UNITED STATES OF AMERICA
NUCLEAR REGULATORY COMMISSION

U.S. Department of Energy
(High Level Waste Repository)

Docket No. 63-001

THE NUCLEAR ENERGY INSTITUTE'S PETITION TO INTERVENE

Figure 1. Comparison between the disposal of a 21-PWR waste package with a TAD disposal overpack and DPC disposal, assuming 100 percent of the waste packages are DPCs. (EPRI, 2008a, Figure 19, page 6-2).

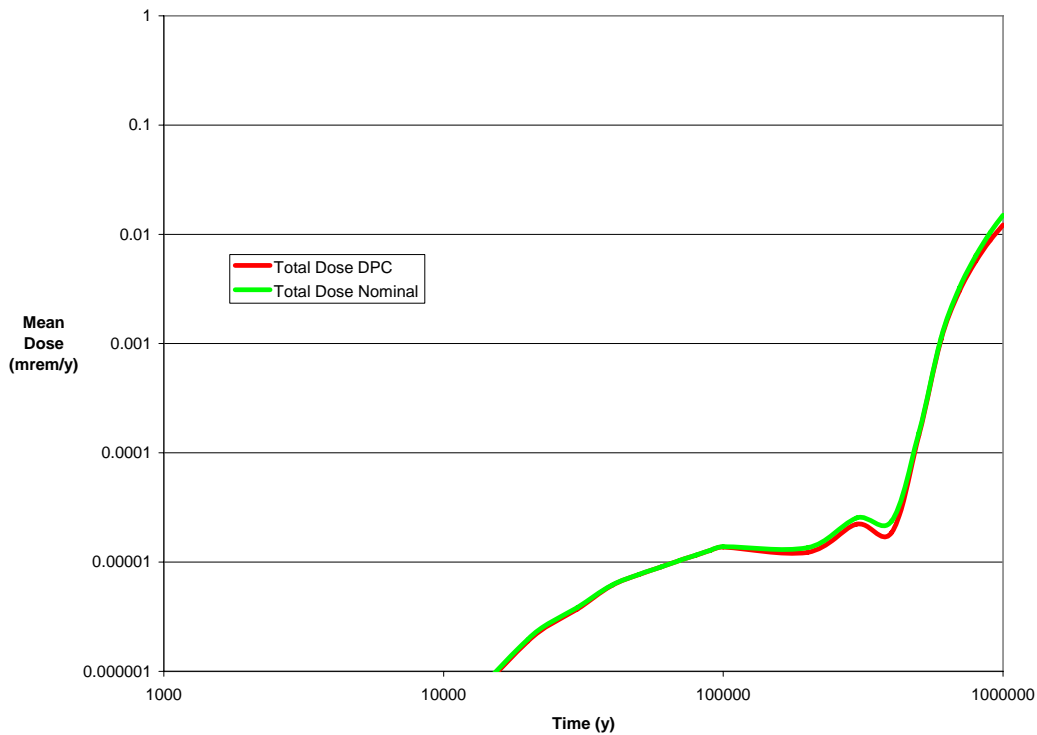
70. (MK) For TSPA analyses, EPRI concluded that only very minor differences exist between DPC disposal and TAD disposal for a variety of scenarios, assumptions, and sensitivity analyses. EPRI 2008 at p. 8-1. The comparison between TAD disposal and DPC disposal for the nominal scenario is shown in Figure 1 below. Evaluations were conducted for the nominal scenario, for the credible alternative scenarios of volcanism and seismic disruption, and for a scenario that has been screened from TSPA because of low probability: the criticality scenario. In all analyses, both DPC disposal and TAD disposal demonstrated acceptable post-closure performance.

Figure 1: Decision Tree for the Function of the Drip Shield to Prevent Seepage Drips from Contacting the Waste Package.

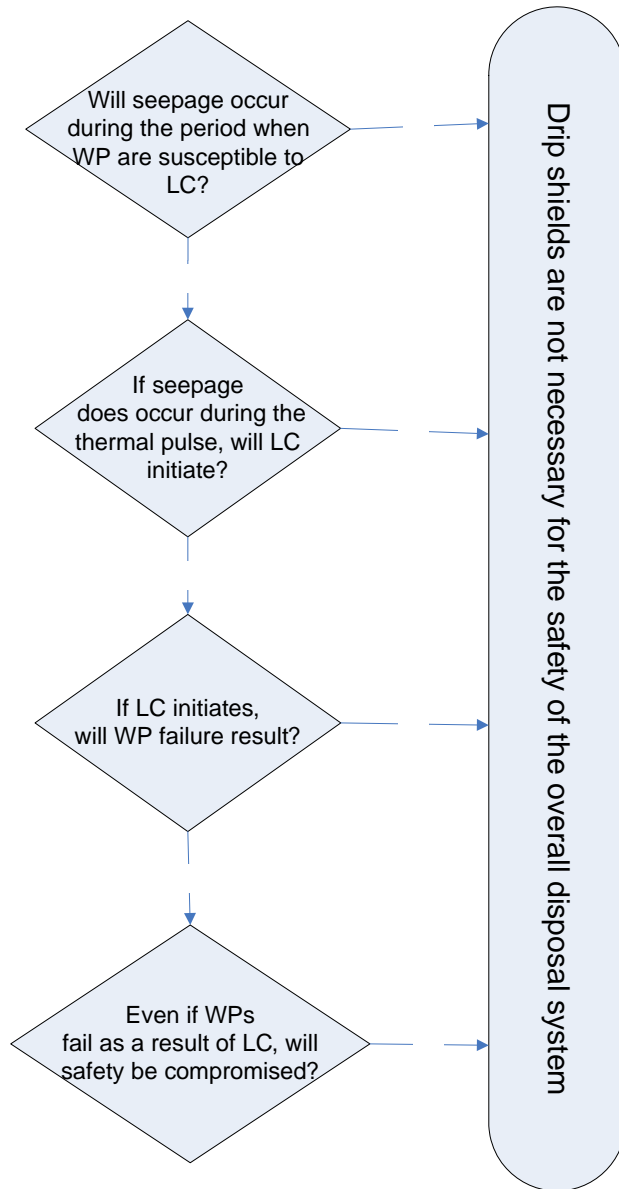
32. (FK) Figure 1 below shows a decision tree illustrating the important factors associated with the function of the drip shield to protect the waste packages from seepage drips, which, under DOE's conservative analyses, could lead to localized corrosion of and eventually failure of some waste packages. As shown in Figure 1 below, for the drip shield to be a necessary barrier, each of the questions in the decision tree must be answered in the affirmative. If any one of these questions is answered negatively then the failure mechanisms postulated by DOE are not credible and, hence, the drip shield is not necessary. (The abbreviations "LC" and "WP" in Figure 1 mean "localized corrosion" and "waste package" respectively.)

33. (FK) Localized corrosion is only possible during the period of elevated waste package temperature (greater than 100°C) and then only if seepage waters contact the surface of the waste package, a process that the drip shields were designed to prevent. The first necessary process is the seepage of water into the drift during the period of time that the temperature of the waste package is hot enough (i.e., during the initial thermal pulse) to support localized corrosion. Although seepage is considered possible, the amount of seepage water is considered to be significantly less than that assumed by DOE, as outlined below. The second necessary condition is that localized corrosion initiate. It is accepted here that the initiation of localized corrosion could occur if the composition of the seepage water is aggressive (i.e., a high chloride

concentration and a low concentration of inhibitive ions, such as nitrate, sulfate, and bicarbonate). Third, if localized corrosion initiates, it is necessary that it penetrate the waste package if it is to affect the safety of the system. In this regard, it is my opinion that the DOE analysis is overly conservative and ignores processes that will lead to the cessation of this form of corrosion. Fourth, even if one assumes that waste package failure will occur by localized corrosion, the safety of the overall multi-barrier system will not be compromised. Here, again, I believe that the DOE analysis is overly conservative.

Figure 2: Decision Tree for the Function of the Drip Shield to Prevent Rockfall from Causing Structural Failure of the Waste Package

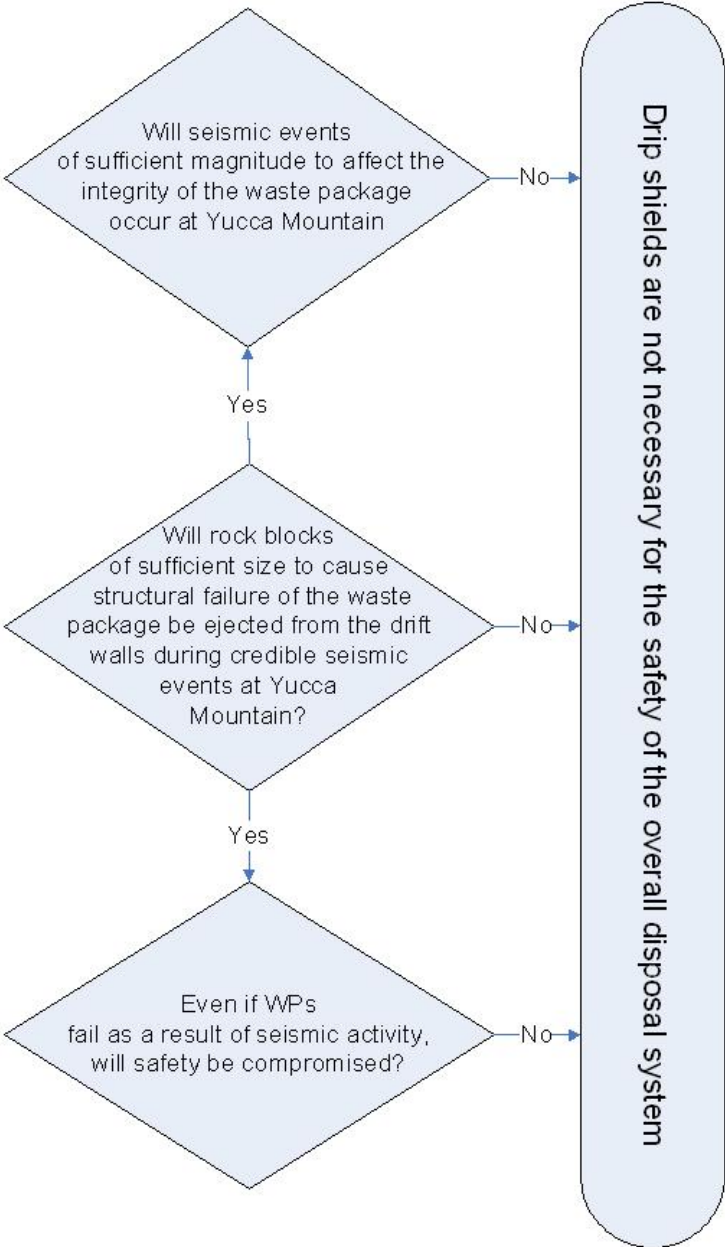
47. (FK) The decision tree in Figure 2 outlines the necessary processes that must occur for rockfall to cause structural failure of the waste package. The first requirement is that seismic events of sufficient magnitude must occur at Yucca Mountain. DOE’s conservative assessment of the magnitude of possible seismic events at Yucca Mountain results in an over-estimate of the credible size of rocks that could be ejected from the drift walls. Second, for rocks of credible size, the kinetic energy of these rocks must be sufficient to puncture or otherwise structurally fail the waste package. Finally, even if a few waste packages do fail because of

impact from large rocks, the safety of the entire repository system may not be compromised if the number of affected waste packages is small or if the remaining natural and engineered barriers provide sufficient containment. In addition to a conservative assessment of structural failure of the waste package by ejected rocks, DOE's analysis of structural failure by seismically-induced vibratory ground motion is also conservative, as discussed below.

Figure 3: Decision Tree for the Function of the Drip Shield to Prevent Rockfall from Damaging the Waste Package Leading to Stress Corrosion Cracking Failures

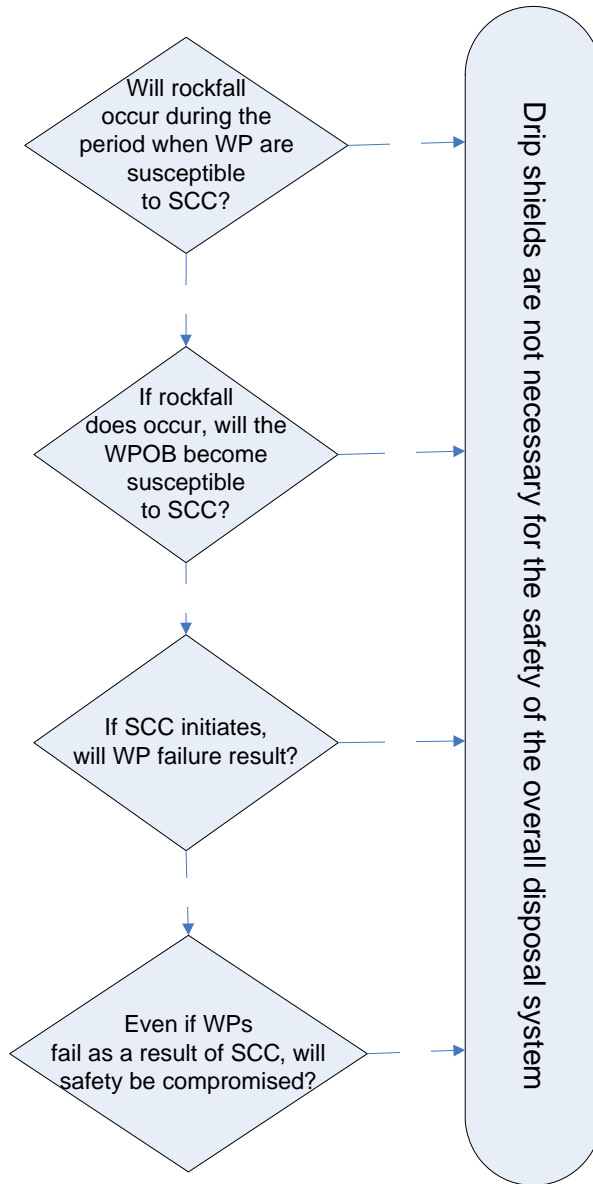
55. (FK) The decision tree in Figure 3 outlines the necessary processes that must occur for rockfall-induced waste package failure by SCC to be important to waste isolation. The first prerequisite for rockfall-induced SCC is that rocks either impact or accumulate on the waste package surface as a result of seismic activity. DOE's conservative assessment of the magnitude of possible seismic events at Yucca Mountain results in an over-estimate of the amount of rockfall in the drifts. Second, initiation of SCC requires that three criteria be met: (1) the tensile residual stress imparted by the rock impacts or accumulated rock pile exceed a threshold value; (2) the seepage water composition must be supportive; and (3) the electrochemical corrosion potential must exceed a threshold value. DOE conservatively ignores the latter two in its analysis. Third, if SCC initiates, the crack must propagate entirely through the wall for waste package failure to occur. It is conservatively assumed here that, once initiated, an SCC crack will propagate to failure. Fourth, even if a few waste packages do fail by SCC, the safety of the entire repository system may not be compromised if the number of affected waste packages is small or if the remaining natural and engineered barriers provide sufficient containment.

Figure 4. Comparison of EPRI’s Base Case (a) and No Drip Shield (b) TSPA Results

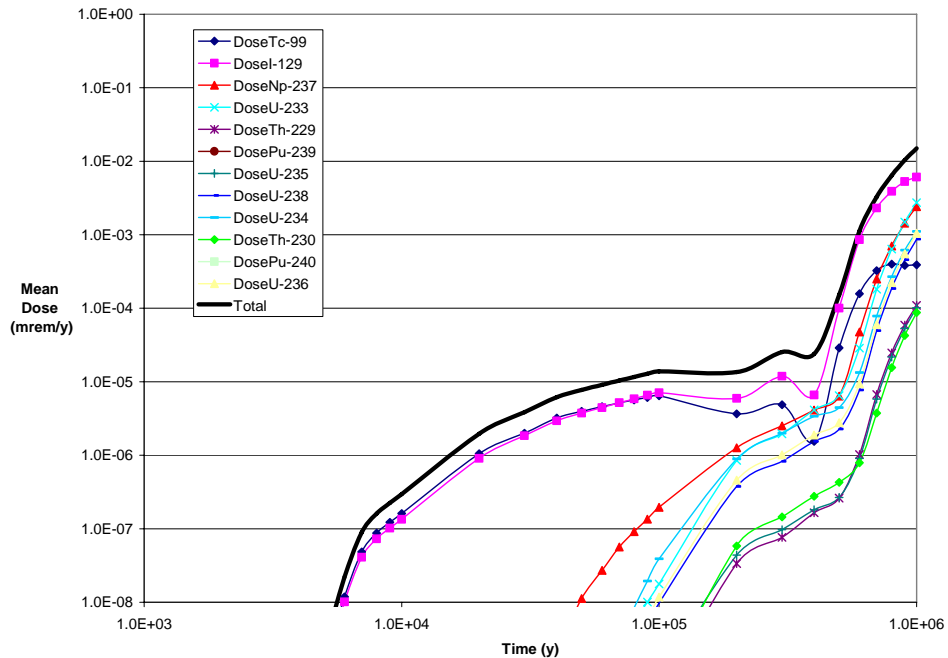
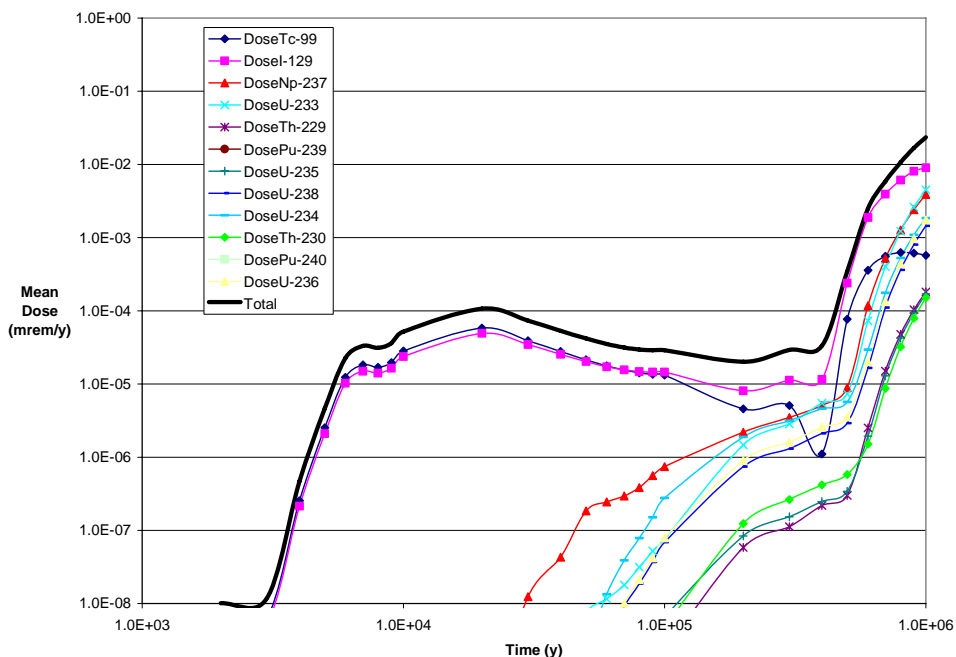
71. (MA) The results of a sensitivity analysis in which the drip shields are assumed to be absent is shown in Figure 4(b). As EPRI noted (EPRI 2008, p. 6-17) there is a moderate increase in doses at early times associated with the waste package that is assumed to be initially failed due to manufacturing defects, but the change in peak dose without the presence of the drip shields is negligible.
